Revision notes on Manuscript No. NHESS-2023-180

Responses to the Comments Raised by Reviewer #1

Fig.1 Rainfall distribution of the scenario simulations.

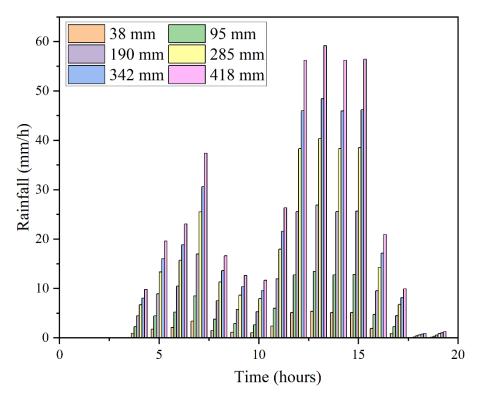
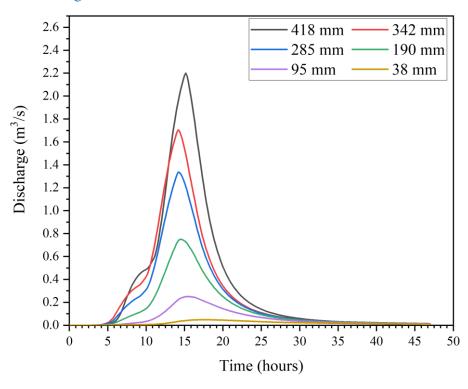
4. The same triggering rainfall, and non-triggering rainfall events that have been used to select the zone thresholds have been used to check the performance of the proposed thresholds. This is an important limitation. The recorded discharges of such events are significantly different, and of course it is possible to separate very well between the events and no-events (Fig 13 and Fig 14). Do you have proof that all rainfall events resulting in larger discharges than the one that triggered the debris flow in 2013 would also result in debris flow events? Similarly, what about rainfall events that result in slightly lower discharges than the rainfall that triggered the debris flow, are you sure

any of them could trigger a debris flow?

To further demonstrate the feasibility of the threshold framework, we have also conducted several extra scenario simulations. Specifically, we modified the input rainfall events, varying the cumulative amount from 10% to 110% of the original rainfall that triggered the 2013 debris flow. The rainfall distribution is presented in Fig. 1. The cumulative input rainfall ranges from 38 mm to 418 mm, with the original value that triggered the 2013 debris flow being 380 mm. The calculated discharge for each scenario is shown in Fig. 2. Additionally, the calculated peak discharge and the corresponding proportion of triggering cells based on the Thresholds G are detailed in Table 2.

The calculated peak discharge from the rainfall that triggered the 2013 debris flow is 2.0 m³/s. As shown in Table 2, rainfall events resulting in discharges greater than the one in 2013 could also result in debris flow events, with the calculated proportion of triggering cells for a 418 mm rainfall event being 48%. Even slightly lower discharges than the 2013 event may trigger a debris flow, as indicated by the 342 mm rainfall event, which has a calculated triggering cell proportion of 44%. This demonstrates that the calculated proportion of triggering cells is consistent with the change in the input rainfall.
